DEFECT INSPECTION REPORT

Name	Client Name
Address	Address
Date of Inspection	2025-11-01
Weather	Clear
Building Type	2 Store Terrace House
Inspected By	Muhammad Fikri bin Ab Rahman – Building Surveyor, Registered under Royal Institution of Surveyors Malaysia (RISM)

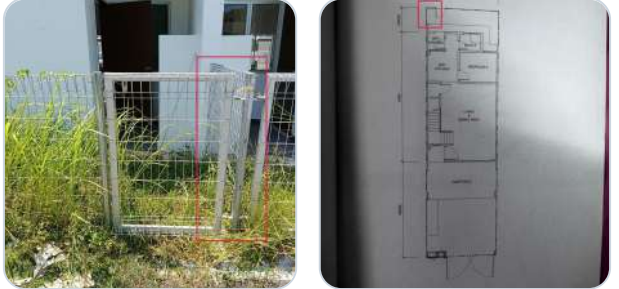
Location	Tag	Defect & Description	Pictures
Car Porch Floor	6	Jointing Issue Visible gaps	
Car Porch Floor	7	Jointing Issue Visible gaps at floor tile grouting	
Car Porch Floor	8	Major defects Crack on floor slab

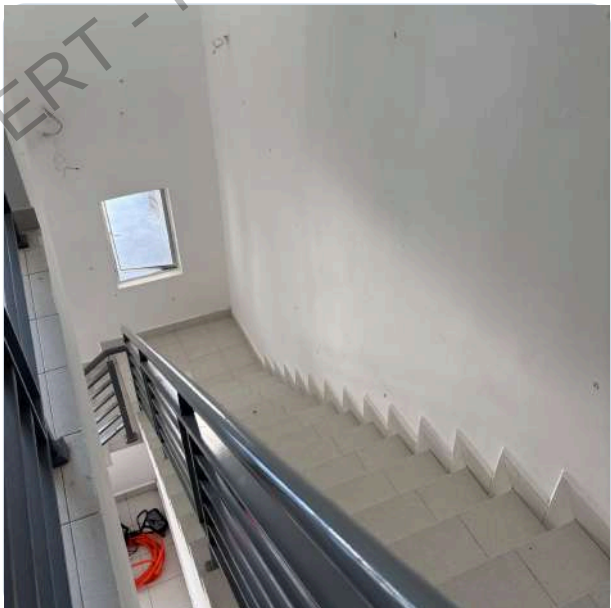
Location	Tag	Defect & Description	Pictures
Car Porch Floor	9	Major defects Improper cutting on tiling	 
Car Porch Floor	10	Minor defects Crack on floor slab	 
Car Porch Floor	11	Minor defects Dented, chipping on floor slab

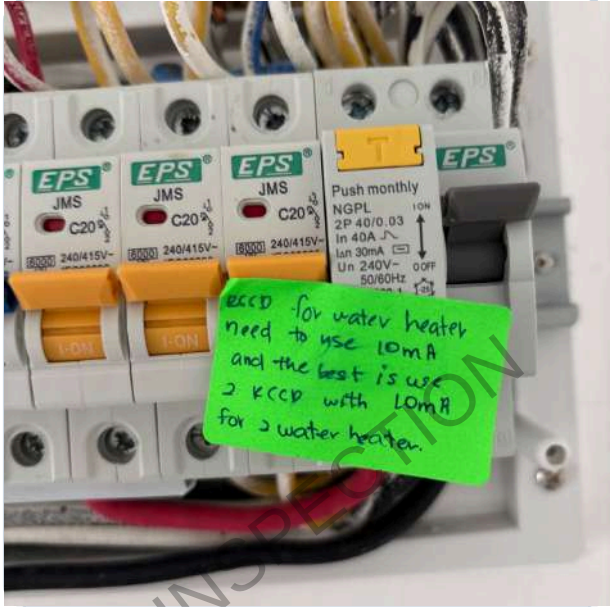
Location	Tag	Defect & Description	Pictures
Family Area Wall	170	Alignment issues Wall misaligned	  
Family Area Wall	171	Finishing issues Stains on painted wall

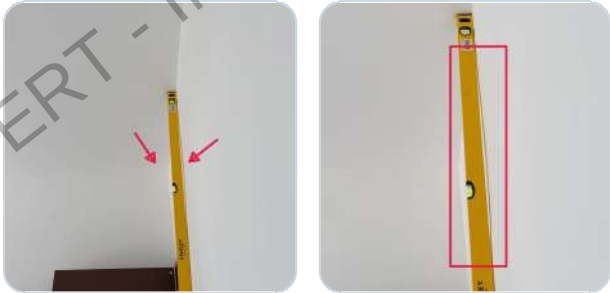
Location	Tag	Defect & Description	Pictures
Family Area Wall	172	Minor defects Dented and crack on all painted wall	   
Family Area Ceiling	173	Finishing issues Stains on ceiling surface	 
Family Area Ceiling	174	Minor defects Crack and chipping on ceiling surface

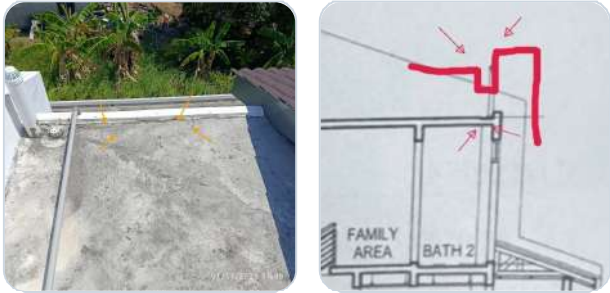
Location	Tag	Defect & Description	Pictures
Flat Roof Wall	296	Minor defects Crack on wall surface	
Flat Roof Ceiling	297	Major defects Damaged on ceiling board
